Consultores de Radiacion
Medical e Industrial
David Rhoe
La Villa de Torrimar
Calle Rey Luis #441
Guaynabo, PR 00969

August 10, 1998

Subject : License application dated March 25, 1998 (Docket No. 030-34704, Control No. 257874)

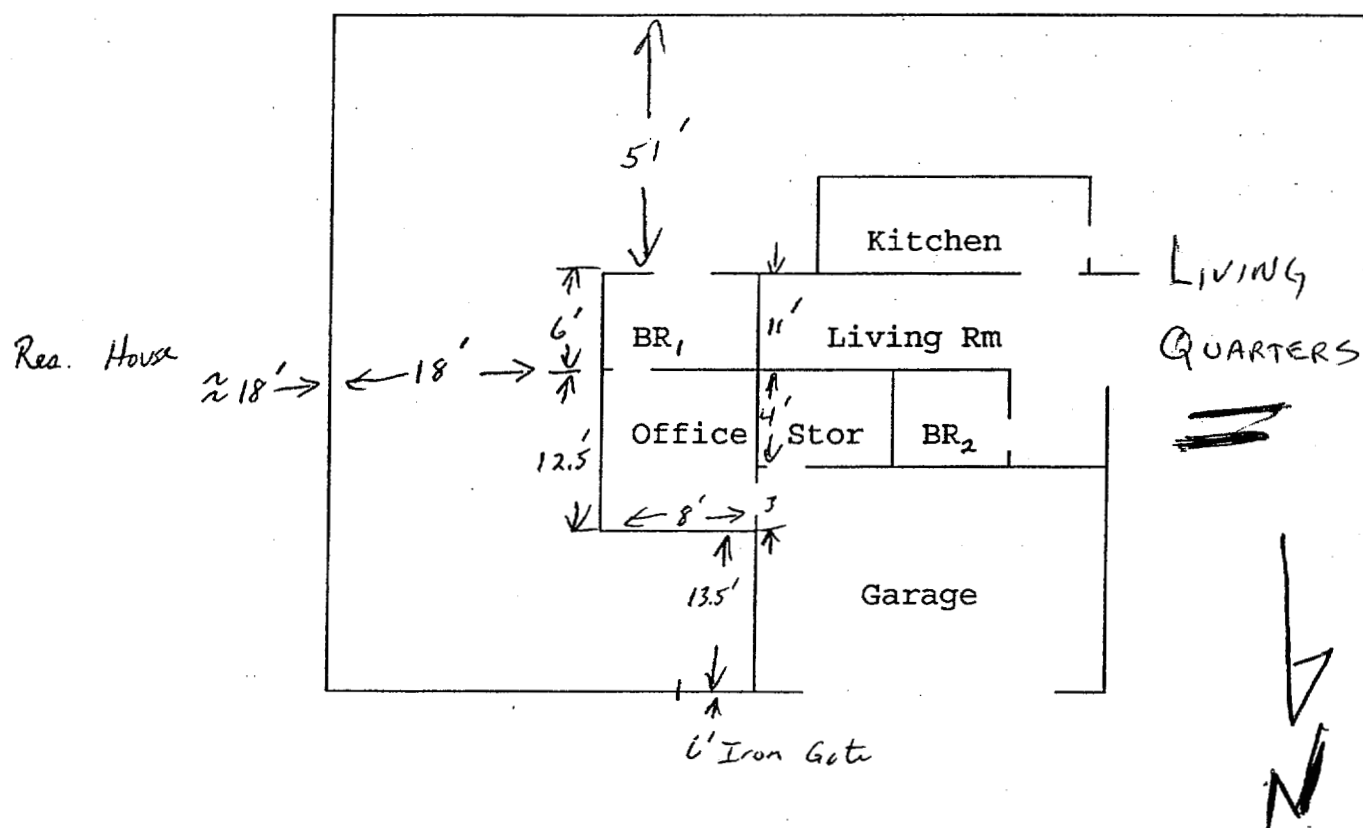
b. Please see the area diagram of my facility. The office room is where the unit will be stored, used and secured when it is not in use. (Attachment 1)

*exempt
gty.*
5. The radiation sources (>10 uCi) will be secured from unauthorized removal in a secured room labeled office in the diagram. The two doors will be secured when the room is vacant.
